# Proposal for Parallel SCSI: Increase Transfer Rate and Improve Error Detection

To: T10 Technical committee

From: Jim McGrath

Date: July 11, 1998

Figure 2 -- CRC\_AVAILABLE timing

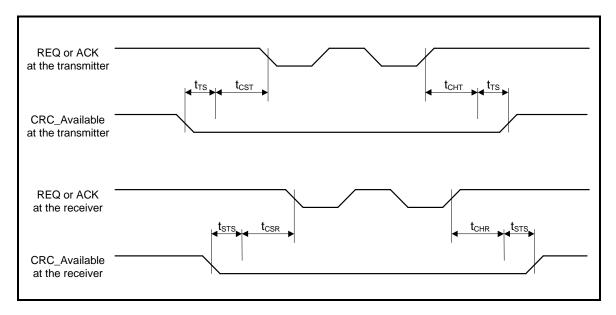
[Note: in the second  $t_{STS}$ , there should be additional setup time to allow CRC\_AVAILABLE to transition. Following the precedence for setup to CRC\_AVAILABLE, it is suggested that an extra 10 ns setup be added here. – CC\_AVALAIBLE setup time is 10 ns additional on either assert or deassert with request to REQ.]
